8. Well Name and No.
DRICKEY QUEEN SAND UNIT 149. API Well No.
30-005-0089710. Field and Pool or Exploratory Area
CAPROCK-QUEEN11. County or Parish, State
CHAVES COUNTY COUNTY, NM**SUBMIT IN TRIPLICATE - Other instructions on page 2**

REMANT OIL OPERATING IS PLANNING ON PLUGGING THE DRICKEY QUEEN SAND UNIT #14 PENDING BLM APPROVAL. PLEASE FIND ATTACHED A "CURRENT WELLBORE DIAGRAM" AS WELL AS A "PROPOSED" POST P&A WELLBORE DIAGRAM. THIS WELL WILL BE PLUGGED IN ACCORDANCE WITH THE BUREAU OF LAND MANAGEMENT'S "PERMANENT ABANDONMENT OF FEDERAL WELLS: CONDITIONS OF APPROVAL"

**Drickey Queen Sand Unit 14
30-005-00897
Remnant Oil Operating, LLC
September 26, 2018
Conditions of Approval**

Proposed P&A Wellbore

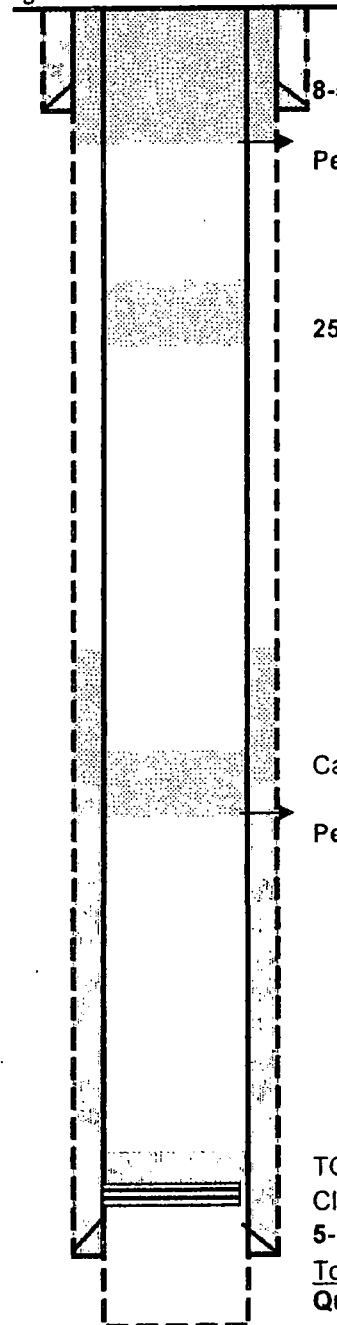
- 1. Operator shall Tag TOC at 2704'.**
- 2. Operator shall place a balanced Class C cement plug from 2,100'-1800' to seal the top of the Yates Formation and bottom of Salt Formation. WOC and TAG.**
- 3. Operator shall perf and squeeze at 1,453' as proposed. Operator shall place a balanced Class C cement plug from 1,453'-1,250' to seal the top of the Salt Formation. WOC and TAG.**
- 4. Operator shall set a 25sx balanced Class C plug at 800' as proposed.**
- 5. Operator shall perf and squeeze at 223' bringing cement to surface to ensure there is a plug 50' below and 50' above the surface casing shoe.**
- 6. See Attached for general plugging stipulations.**
